## PART 21 REPORT INVOLVING TYPE 546NS TRANSDUCERS

"Fisher Information Notice: FIN 2013-01; 9 January 2013

"Subject: Type 546NS Transducers

### CASE VENT INSPECTION PROCEDURE

Figure 1

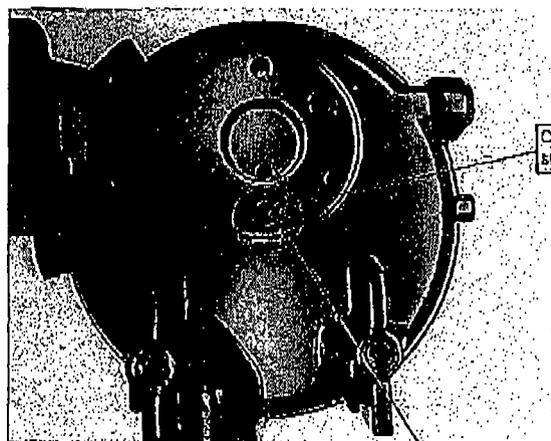
This procedure is to be used to inspect the 546 transducer vent passage between the 546 case and 82 relay for a possible obstruction due to aluminum flash in the vent passage. If the vent passage is found to be obstructed by aluminum flash, the flash may be removed with a punch or other hard pointed object by breaking and removing the flash. The 546 transducer will operate normally once the flash is removed and the relay is re-installed.

1. To remove the type 82 relay, perform step 1. of the Relay Removal and Replacement instructions on page 15 of the instruction manual.
2. Inspect the case vent passage (see figures 1 - 3). The passage should be open and the interior surface of the flash suppressor should be visible through the hole (see figures 1 and 2). If the passage is obstructed with aluminum flash, the passage will appear to be a blind hole (see figure 3).
3. If the passage is obstructed with aluminum flash, use a punch or other hard sharp instrument to break the flash and remove it from the vent passage.
4. Once the aluminum flash is removed, or if no aluminum flash is present, re-install the type 82 relay by performing step 3 of the Relay Removal and Replacement procedure on page 15 of the instruction manual.
5. The 546 transducer is now ready to be placed into service.
